**DOCUMENT 00 91 01**

**AMENDMENT NUMBER ONE**

PROJECT: Correct Cited Safety, Security and Facility Condition Assessments for Bldg 3

VA Project No. 636A6-13-809

**ASD-001**

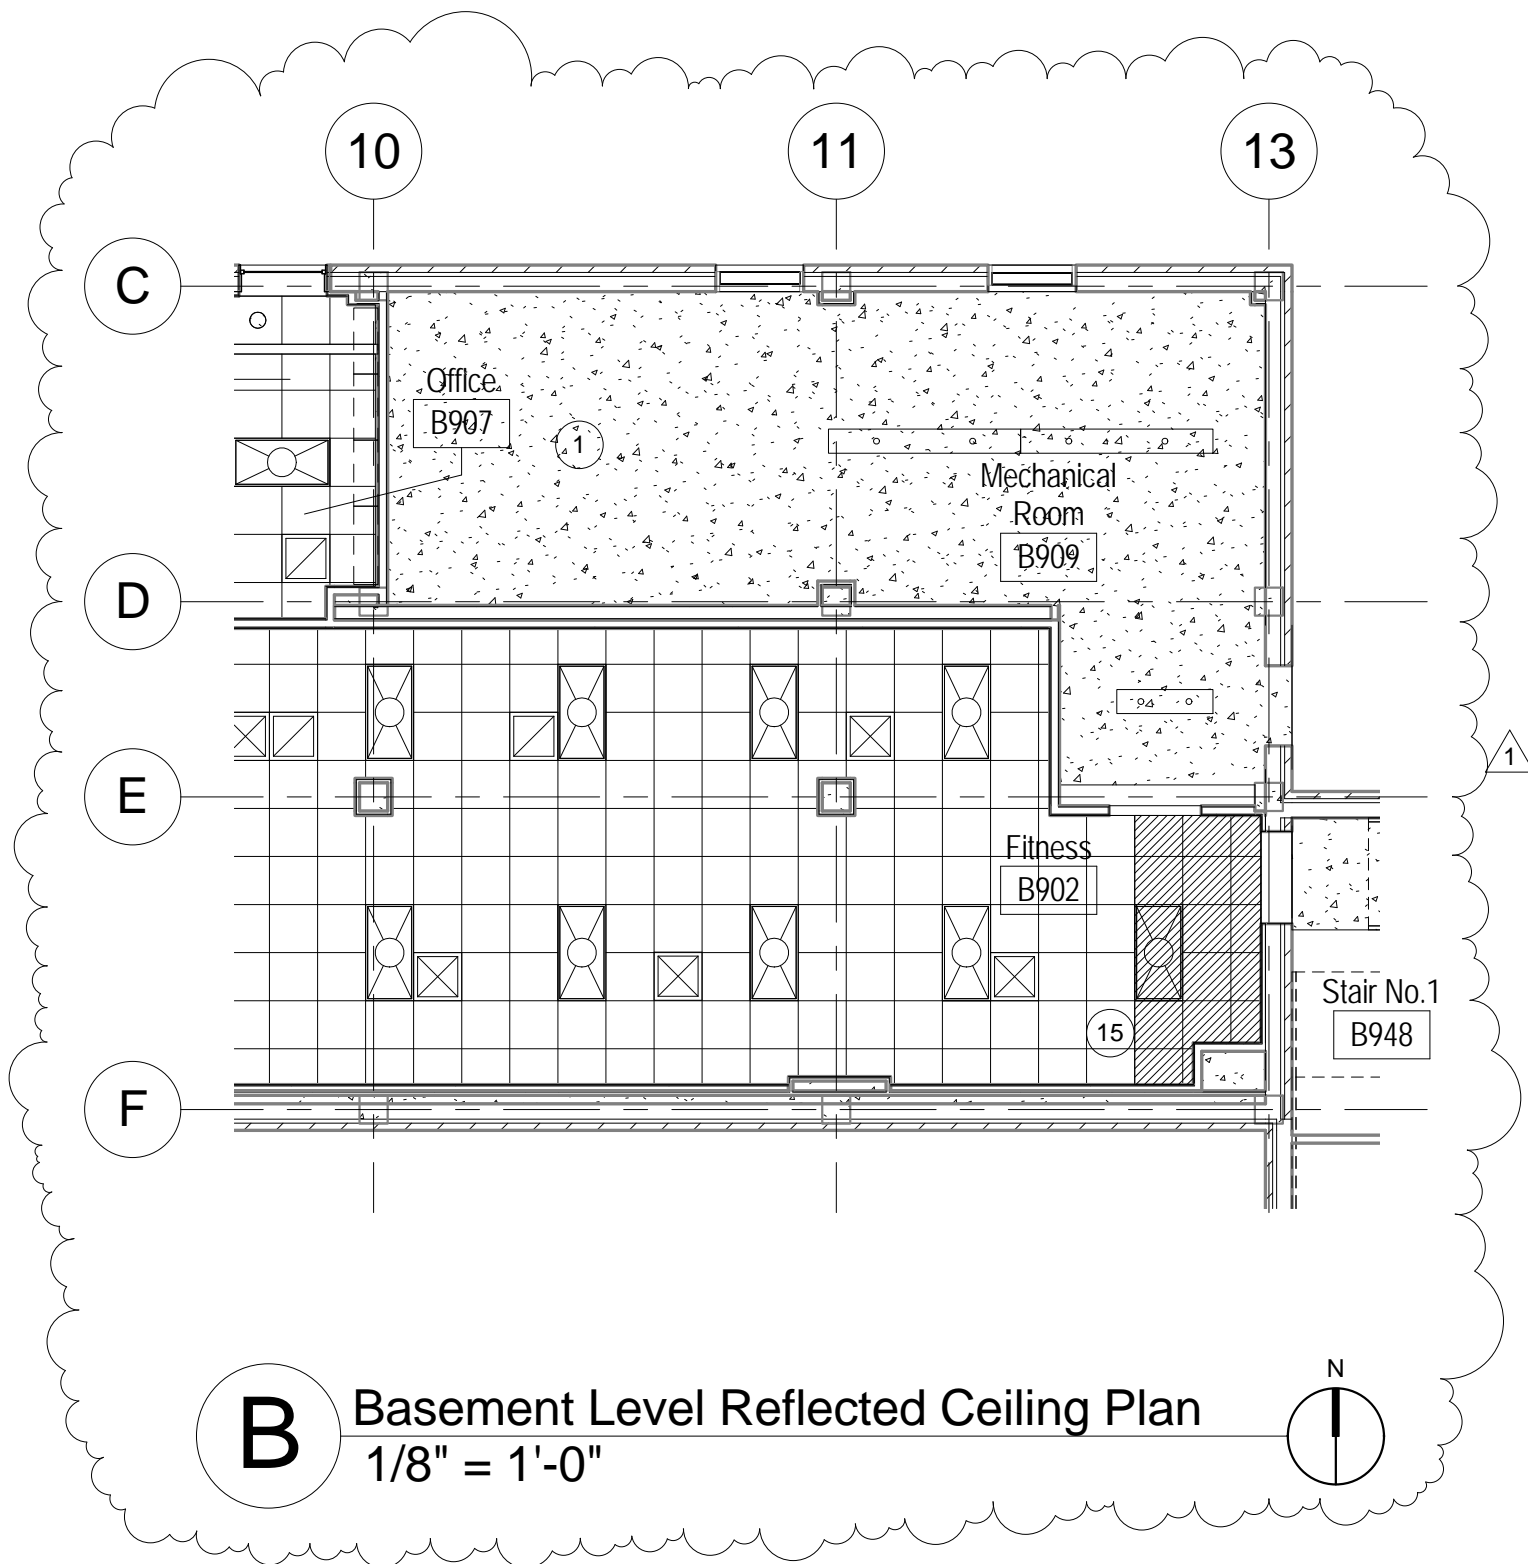
- ITEM #12 SHEET A110-4 – SECOND LEVEL REFLECTED CEILING PLANS
- A. **ADD** B/A110-4 – Basement Level Reflected Ceiling Plan. Refer to ASD-001.
- B. **ADD** Keynote 15 to Keynote Legend. Keynote 15 to read: ***“Replace damaged acoustical ceiling tile located within hatched area.”***

ESD-001

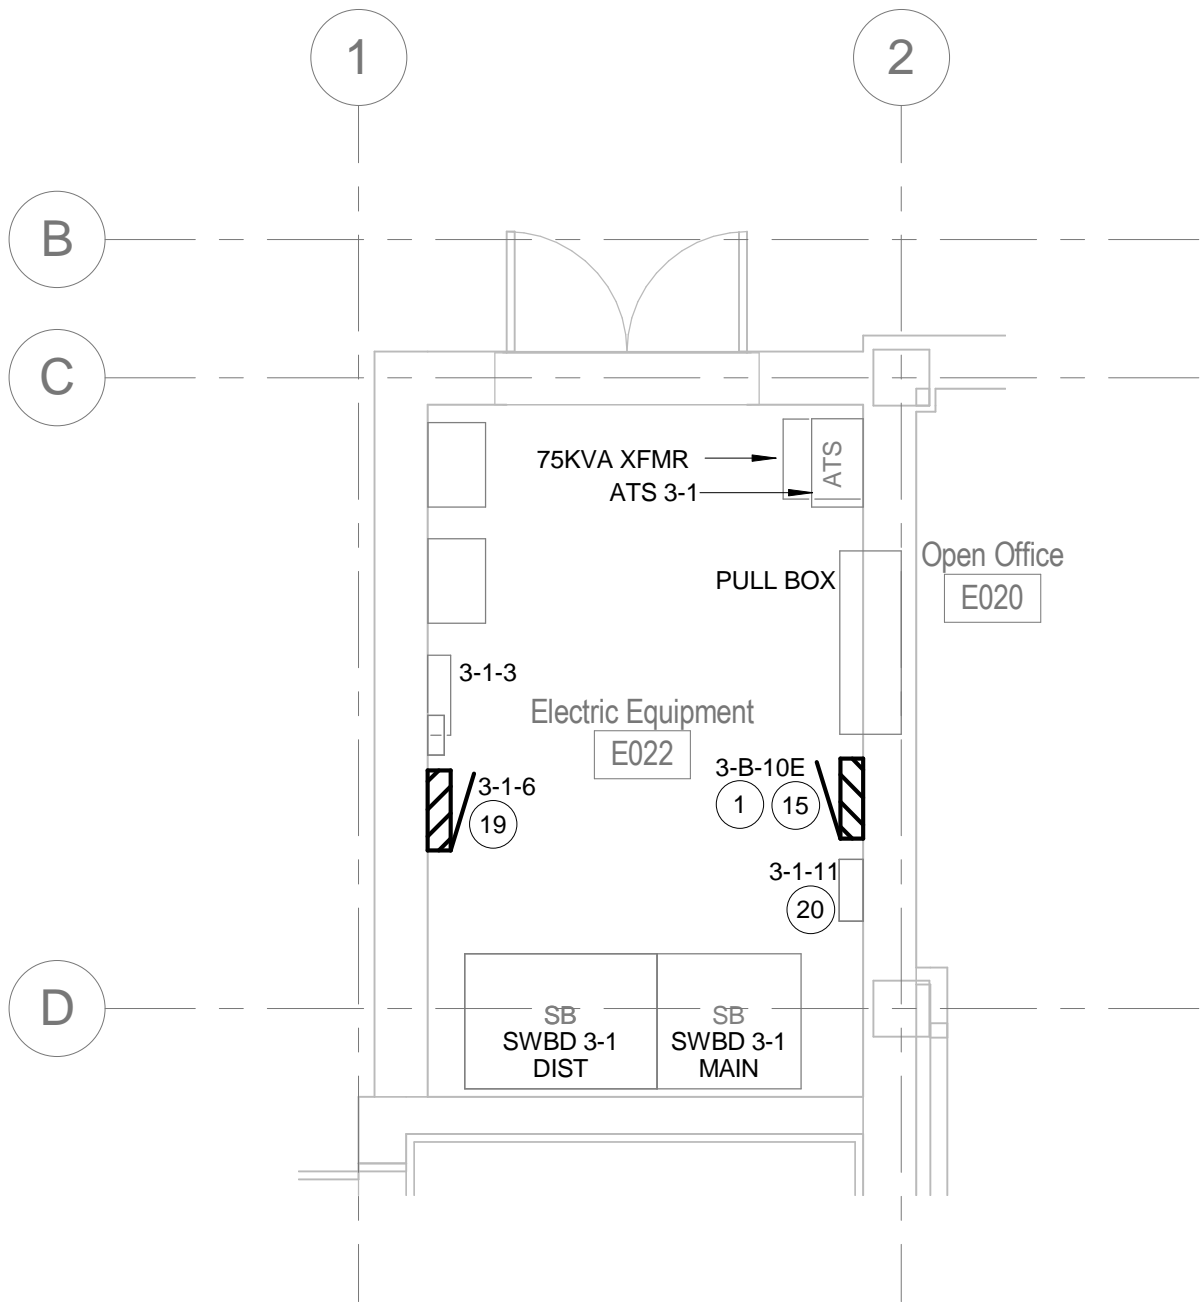
- A. **REVISE** layout of existing equipment in Electrical Room B022 for clarification. Reference attached supplemental drawing ESD-001.
  - B. **ADD** keyed note (19) to panelboard 3-1-6 which reads as follows: ***“Demolish abandoned pull box and associated conduits in panelboard 3-1-6 location.”***
